AIRWORTHINESS BULLETIN

Pacific Scientific shoulder harness retraction reels **AWB** 25-008 **Issue :** 1
Date : 21 October 2005

ALERT SERVICE BULLETIN

RESTRAINT SYSTEMS - OPERATORS OF AIRCRAFT WITH PACIFIC
SCIENTIFIC COMPANY, HTL/KIN-TECH DIVISION
RESTRAINTS INSTALLED

Figure 1. Location of Manufacturer's Date and Marking of Refurbished Parts

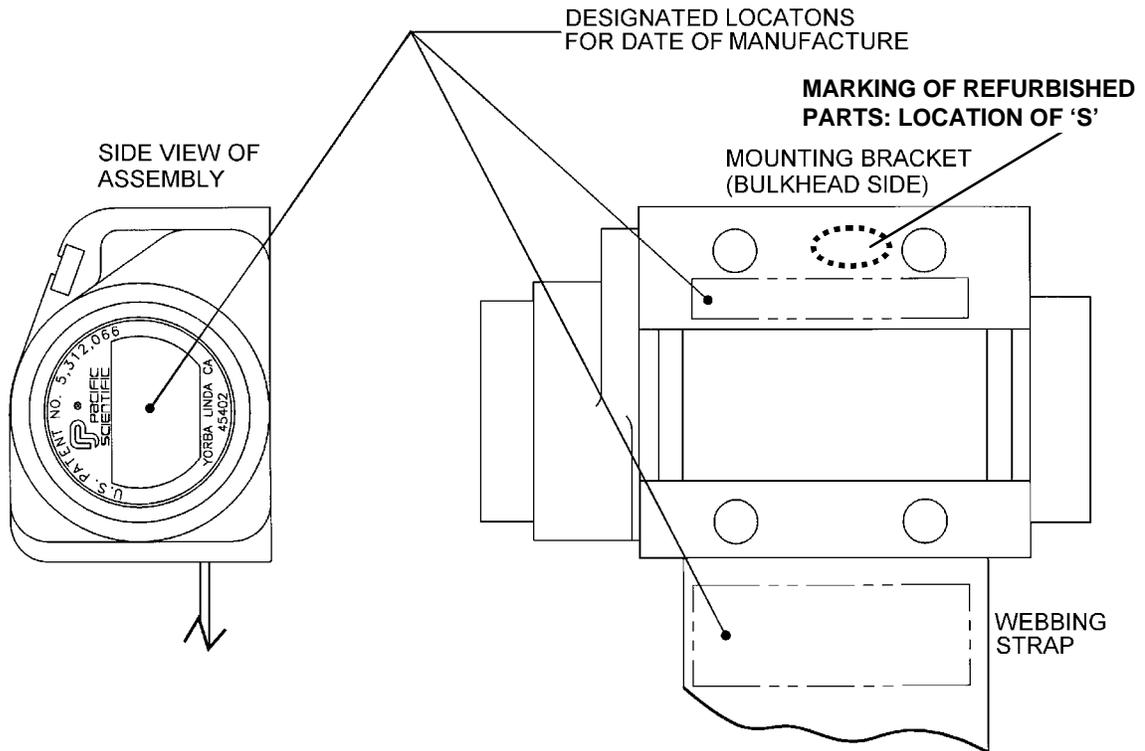
Parts serviced or refurbished will be ink stamped with the date and an “S” on the back of the frame. This stamp will indicate the Aluminum shaft has been replaced with the Steel shaft. (See Figure 1.)
